**From:** [Ann Lynch](#)  
**To:** [Planning and Zoning Main](#)  
**Subject:** Opposition to CU-26-001  
**Date:** Saturday, May 16, 2026 6:55:25 AM

Re: Application CU-26-001

**Submitted to Doraída Arias, Interim Director, Sandoval County Planning & Zoning | 13 May 2026 — V1**

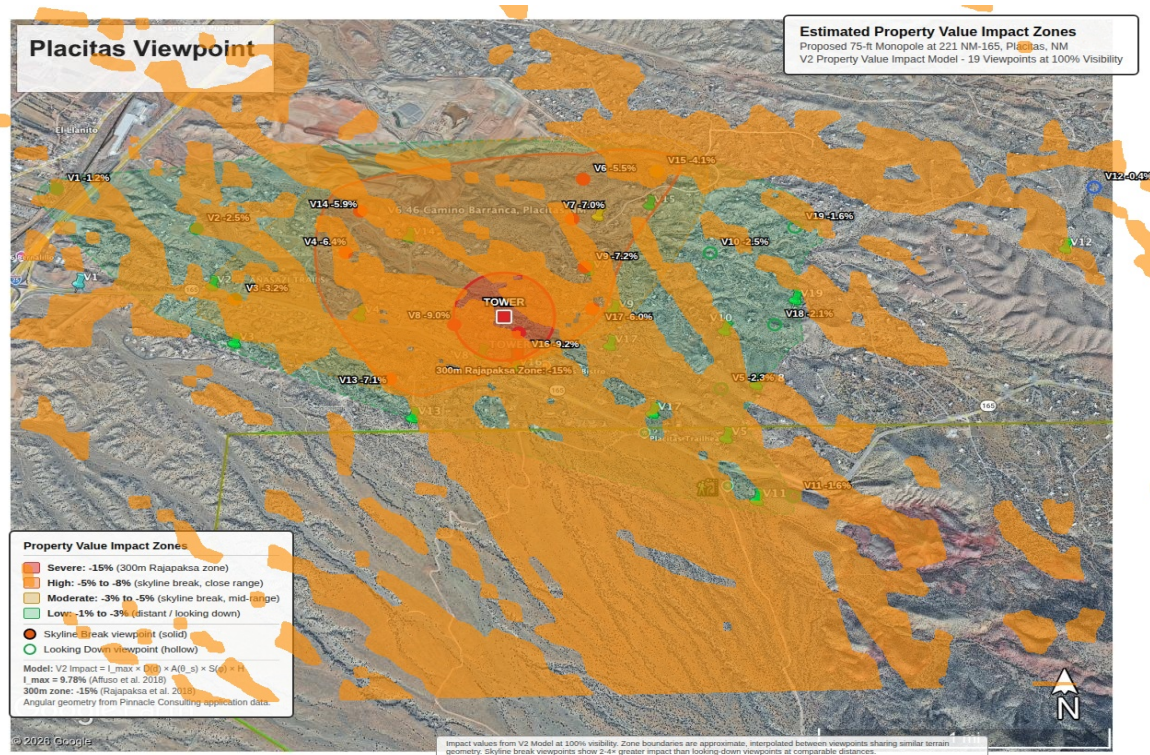
The convergence between the two independent analyses is methodologically important. The Branum viewshed is a pure geometric LOS test against terrain. The V2 property-value model is a per-viewpoint skyline-break visibility calculation against the actual landscape skyline as seen from the viewpoint. The two methods produce the same first-order pattern: the tower is visible (and therefore deliverable in RF terms) from the western and southwestern open terrain, and from the

- **Finding 6.** The convergence between the independent Branum viewshed (Figure 1), the V2 property-value impact overlay (Figure 2), and Verizon's own self-reported coverage map indicates that the geometric LOS test is a reliable proxy for actual service-area delivery in this terrain. The conclusion that the proposed site cannot deliver service to the back-canyon population is therefore not an artifact of any single analytical method; it follows from the underlying geometry of the site.

Figure 3. Biwabkos slide 11 — "RSRP — Current Coverage." Aggregate Verizon network RSRP for the Placitas service area, all existing sites combined. The red ellipse marks the alleged coverage gap. Legend: green ≥ -85 dBm Indoor; yellow ≥ -95 dBm In-Vehicle; red ≥ -101 dBm Outdoor; white < -101 dBm.

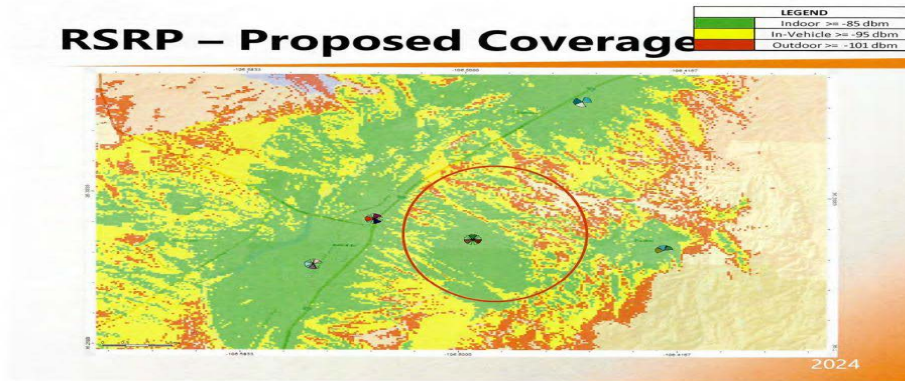
Reading slide 11 (Figure 3) against the geographic features of the Placitas service area, the following pattern is visible:

**Why this matters for the record.** Figure 6 and slides 11 / 12 (Figures 3 and 4) render the same underlying terrain and the same proposed antenna, but they answer different questions and produce visually inconsistent impressions. Slides 11 and 12 show the aggregate Verizon network state and present a coverage pattern that — because it combines the proposed tower's contribution with the existing-tower contributions — looks broadly green across the residential service area. Figure 6 shows the proposed tower's contribution in isolation and reveals that this aggregate-green impression is supplied principally by the existing-tower contributions, not by the proposed tower. The maps in slides 11 and 12 are not analytically wrong, but they are misleading as the evidentiary basis for a coverage-need finding: they hide the proposed tower's actual reach behind the network-aggregate rendering. Figure 6 supplies, in visual form, the marginal-contribution evidence that § 3.1 identifies as the missing analytical artifact — and what that evidence shows is consistent with Part II: the proposed tower delivers signal to the open western valley already served, and not to the village or the back canyons.

Figure 4. Biwabkos slide 12 — "RSRP — Proposed Coverage." Same aggregate Verizon network with the proposed site added at the marked location. The green expansion is concentrated to the south, southwest, and west of the proposed site — descending terrain, open foothills, and the Bernalillo basin

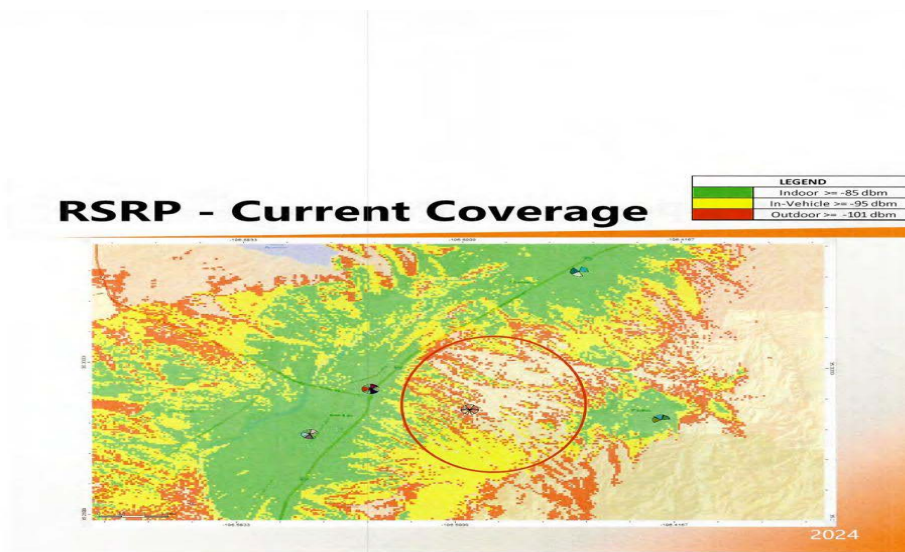
corridor. The eastern back-canyon shadow zones identified in Part II remain largely red (Outdoor edge-of-service) or white (no-service) in the Proposed raster, despite the addition of the new site.

Reading slide 12 (Figure 4) against slide 11:

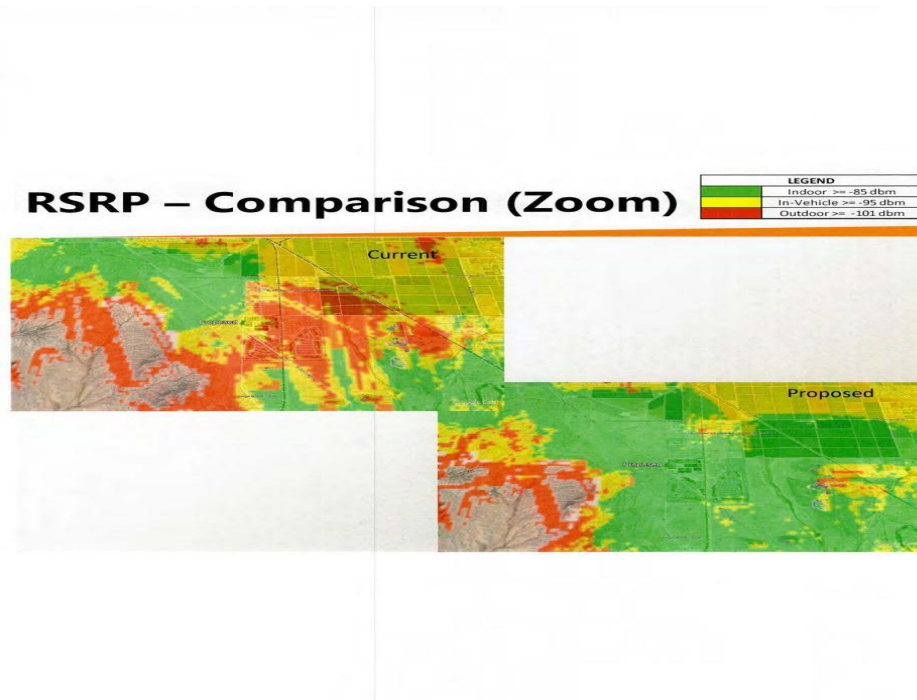
Slides 13 and 14 reproduce slides 11 and 12 as half-panels in a side-by-side Comparison frame. They display the same data at the same projection. The Comparison frame makes the visual interpretation easier — one can see directly where the green (Indoor) region grows from slide 13 (Current) to slide 14 (Proposed). The growth occurs predominantly to the south and southwest of the proposed-site marker: into the open Sandia foothills, into the descending terrain toward NM-165 west, and toward the Bernalillo basin.

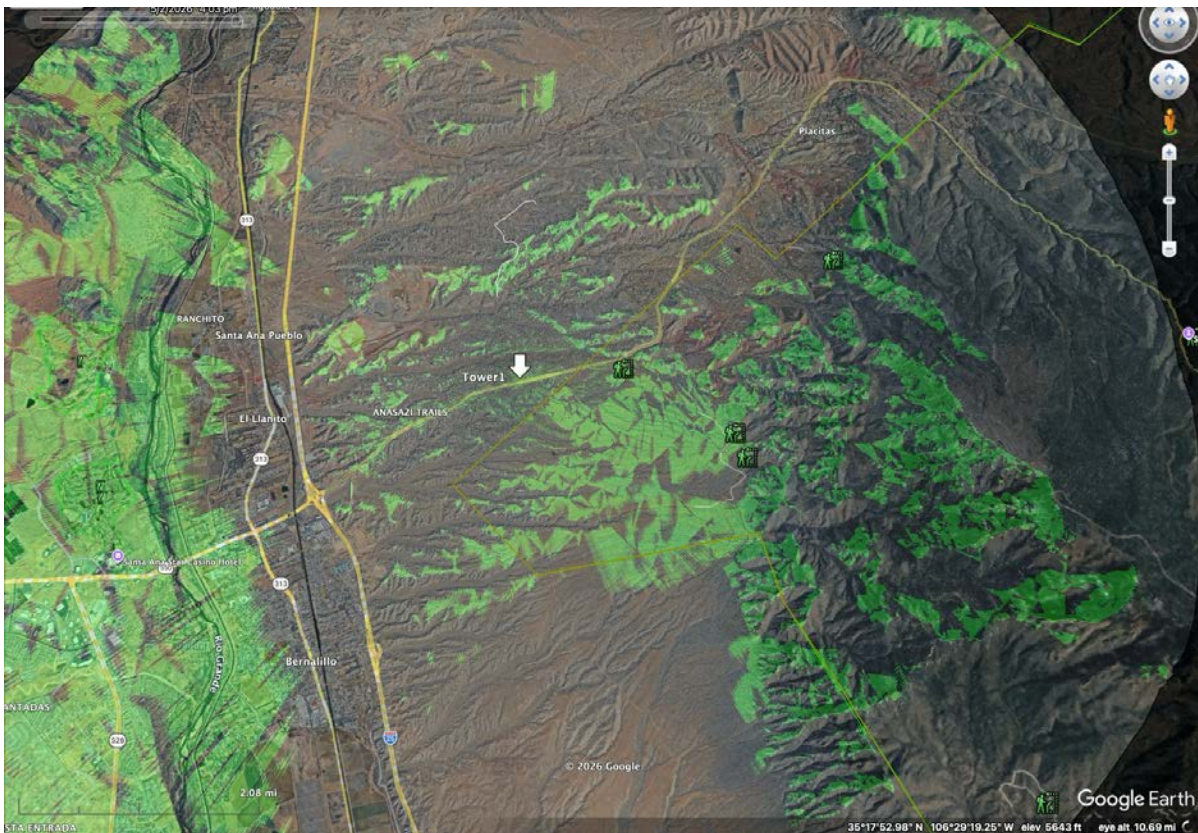
The map that would actually answer the zoning question — what the proposed tower contributes by itself — is absent from the submission. When the proposed tower is rendered alone (Part III, Figure 6), its actual reach falls on Bernalillo, the I-25 corridor, Santa Ana Pueblo, the gravel mine, and federal land. The back canyons of residential Placitas appear as dark gaps within the green. This is the visual evidence the Commission needs, and the applicant did not provide it.

Three observations follow directly from Figure 6:

- **The historical Village of Placitas is not in the green coverage zone.** The labeled "Placitas" location on the upper-right of Figure 6 sits in the dark, unshaded area. The Overlook ridge between the proposed RAD center and the village — Part II § 2.2 — blocks the geometric line of sight, and the village receives no marginal signal from the proposed tower. This is the Class D geometric shadow developed in Part II § 5.4, made directly visible here in a single frame.

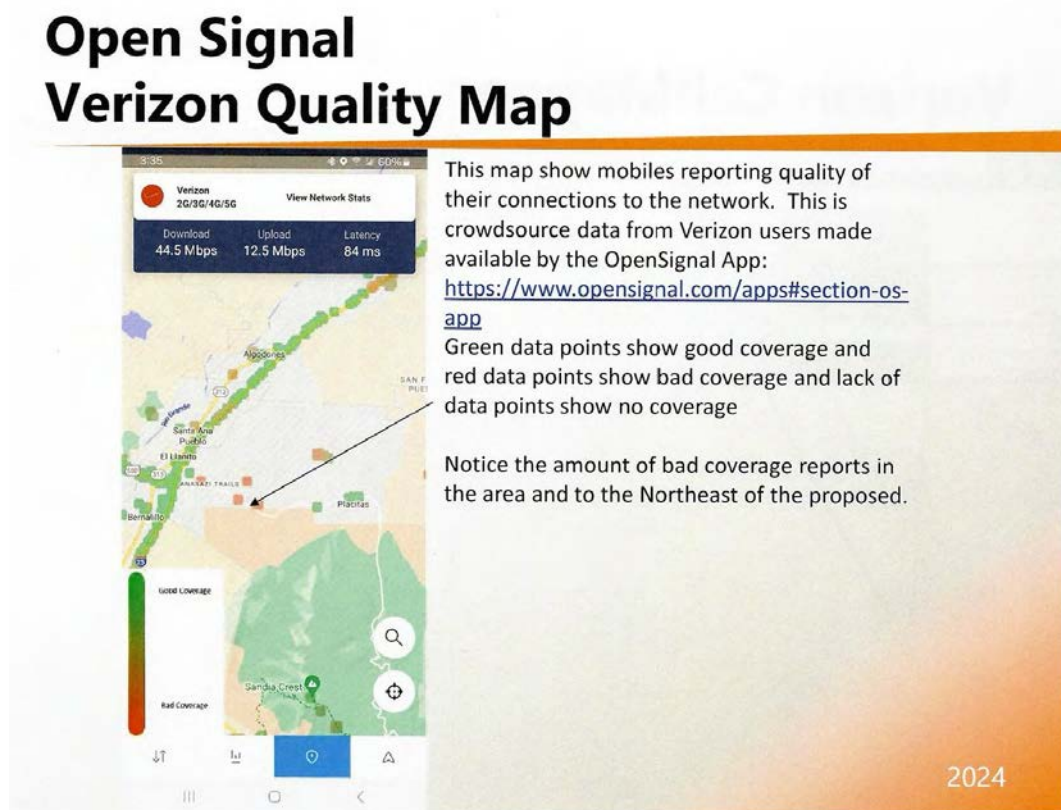
Critically, the corridor pattern in Figure 8 cannot be extrapolated outward from the corridor to the broader rural service area. The corridor pattern reflects the carrier's intentional choice to serve high-traffic transportation corridors; it does not reflect the coverage profile in the lower-density residential interior, and it does not establish any premise about coverage in the back canyons identified in Part II as the geometrically shadowed neighborhoods.

Visual inspection of Figure 8 in the Placitas service area reveals fewer than approximately ten red / brown dots — individual user-reported bad-coverage measurements scattered through a rural service area covering tens of square miles. The applicant's narrative characterizes these as evidence of widespread bad-coverage reports. Three observations:

- **The absolute count is small.** A literal count of red / brown dots visible in the Placitas residential service area in Figure 8 is fewer than ten. This is not a "large amount" of bad-coverage reports — it is a sparse handful of single-measurement events.

Figure 9. Biwabkos slide 2 — "Coverage vs Capacity." The applicant's own definitions, with bulleted sub-criteria for each category.

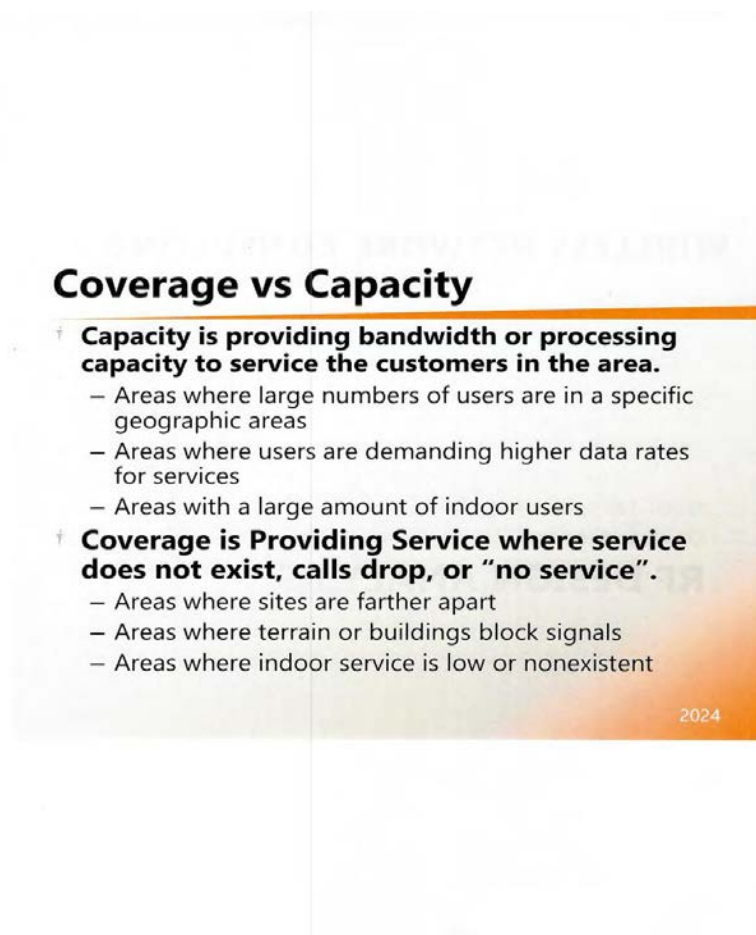
The applicant defines "Capacity" as "providing bandwidth or processing capacity to service the customers in the area," with sub-criteria including "Areas where large numbers of users are in a specific geographic areas," "Areas where users are demanding higher data rates for services," and "Areas with a large amount of indoor users." The applicant defines "Coverage" as "Providing Service where service does not exist, calls drop, or 'no service'," with sub-criteria including "Areas
